SIGNIFICANT HAZARD INSPECTION REPORT

Preliminary Inspection Report for South Carolina Regulated Dams and Impoundment Structures Regulations R.72-1 through R.72-9

RE: Re-inspection of Dam D-0206, Chester State Park Dam, Chester County

RE: Re-inspection of Dam D-0224, Pineview Lakes Dam 1, Chester County

D-0206 Chester State Park

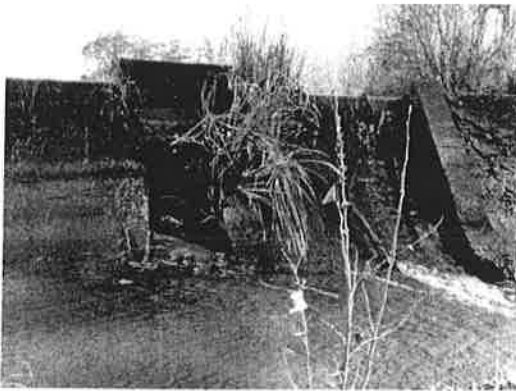
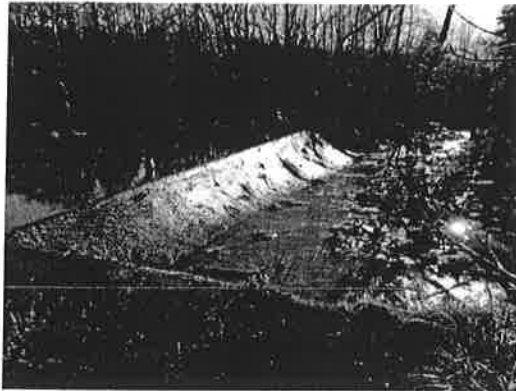
- * Overall dam appears to be structurally sound
- * Given a few issues with the downstream slope
 - trees have grown producing massive roots which could eventually interfere with the stability of the dam
 - sloughing on the slope should be address before future issues arise
 - cut any trees within 20 ft of the toe of the dam
- * given a poor condition because lack of maintenance on the downstream slope.
- * A change of ownership form has been provided please mail back if adjustments have been made.
- * Please update Emergency Action Plan include and mail back to my office with comments addressing the above issues.

D-0224 Pineview Lakes Dam 1

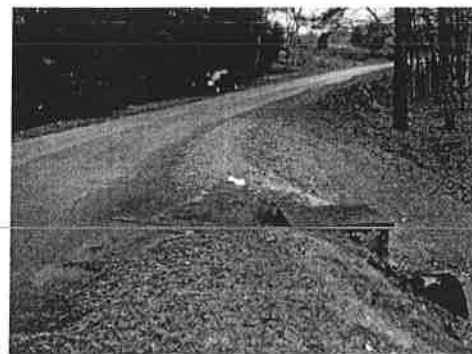
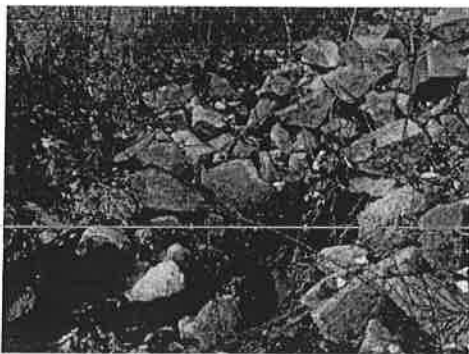
* overall, the dam appears to be structurally sound and well maintained.

* The stump on the upstream should be removed and re-stabilized, but current location prevents major issues.

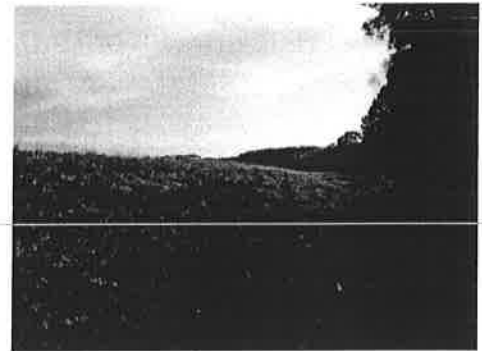
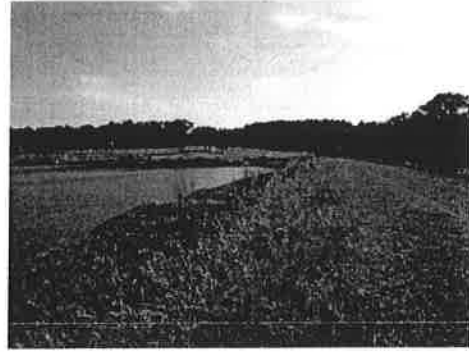
*Overall dam well maintained; would like to see vegetation cut shorter on both slopes of the dam.

*Spoke with landscaping team advised me that is cut about every two weeks

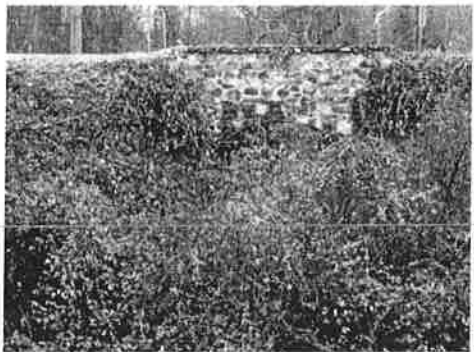
*a little bit of sloughing on slopes just monitor

*overall good condition
